**STAFF REPORT**  
**WEST ALLIS PLAN COMMISSION**  
Wednesday, October 23, 2019  
6:00 PM

- 2A. Application for a Special Use Permit for The Lapham, a proposed restaurant, to be located at 1603 S. 81 St., with commercial parking to be located at 1603 S. 81 St., 16\*\*S. 82 St. and 16\*\* S. 81 St.
- 2B. Site, Landscaping and Architectural Plans for The Lapham, a proposed restaurant with commercial parking, to be located at 1603 S. 81 St., 16\*\* S. 82 St. and 16\*\* S. 81 St. submitted by Ryan Oschmann, d/b/a Bass Bay Brewhouse (Tax Key No. 452-0327-001, 452-0506-000 and 452-0314-000).

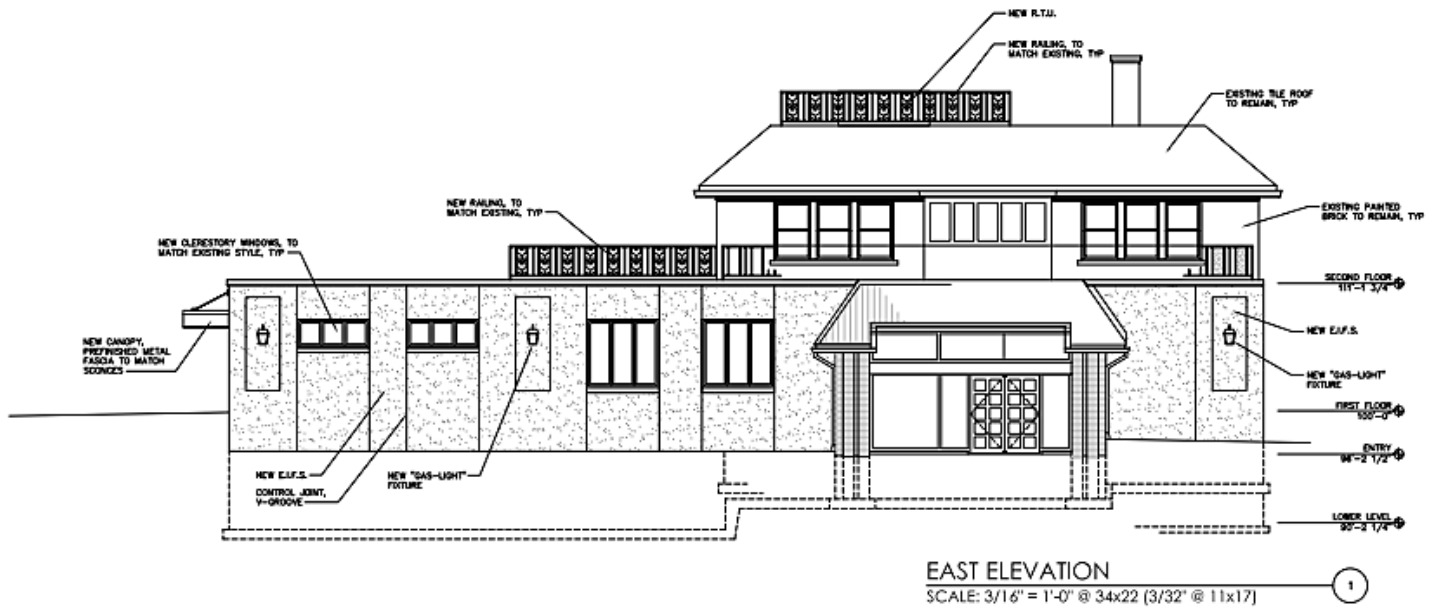
The building's interior will be reconfigured to accommodate indoor and outdoor customer seating, two bars, a kitchen, and will provide for the necessary mechanical and restroom upgrades. A combined 1,465 square foot outdoor seating area will be installed on the second floor of the existing building. The second floor seating area will have a railing surrounding the perimeter. The exterior façade of the building will include gas light

features. The doorway on Lapham Street will be removed, directing people to use the 81 St. and back of building entrances. Staff recommends the use of troweled stucco instead of the proposed EIFS.

Staff has requested that the applicant submit a landscape plan showing the existing condition and what is proposed.

1. Revised Site, Landscaping, and Architectural Plans being submitted to the Department of Development to show the following: (a) Eliminate EIFS from the plans and use troweled stucco where needed; (b) Planned landscaping and identification of number and species of plantings; (c) City Forester approval of the landscaping

species and number; (d) Resealing of existing parking lots; (e) Add a bike rack to the plans. Contact Tony Giron, City Planner at 414-302-8469.
